TRANS/WP.29/GRE/2005/37  
25 July 2005

Working Party on Lighting and Light-Signalling (GRE)  
(Fifty-fifth session, 3-7 October 2005,  
agenda item 20.4.)

PROPOSAL FOR DRAFT AMENDMENTS TO REGULATION No. 112

(Headlamps emitting an asymmetrical passing beam)

"Annex 4 - Appendix 1

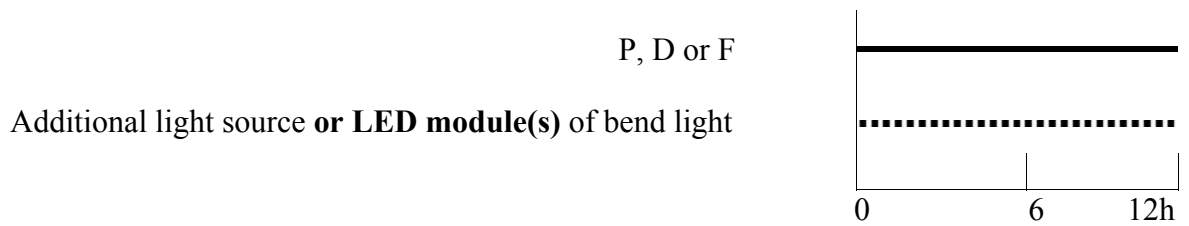
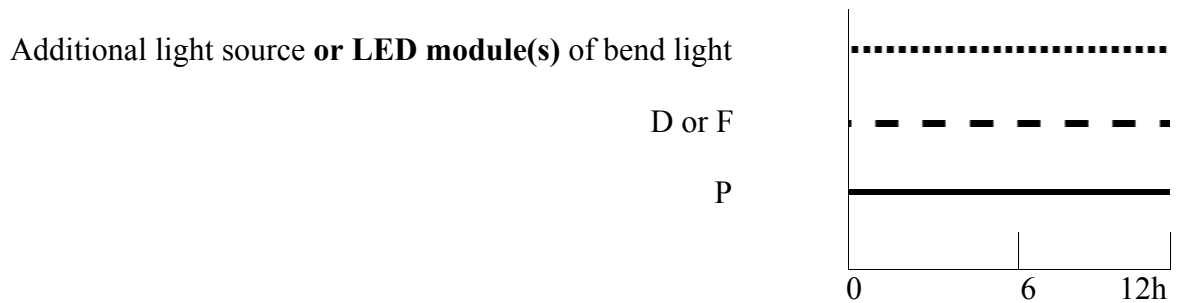
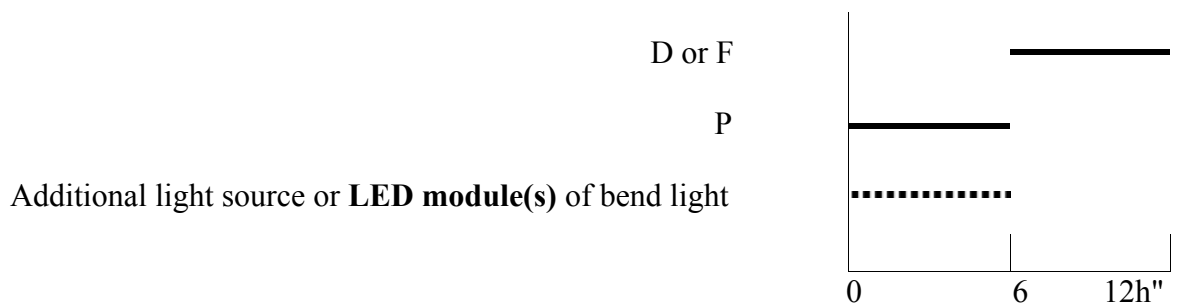
Annex 4 - Appendix 1, amend to read:

OVERVIEW OF OPERATIONAL PERIODS  
CONCERNING TEST FOR STABILITY OF PHOTOMETRIC PERFORMANCE

Abbreviations:	P:	passing beam lamp
	D:	driving beam lamp (D <sub>1</sub> + D <sub>2</sub> means two driving beams)
	F:	front fog lamp
	— — — —	means a cycle of 15 minutes off and 5 minutes lit
	.....	means a cycle of 9 minutes off and 1 minutes lit
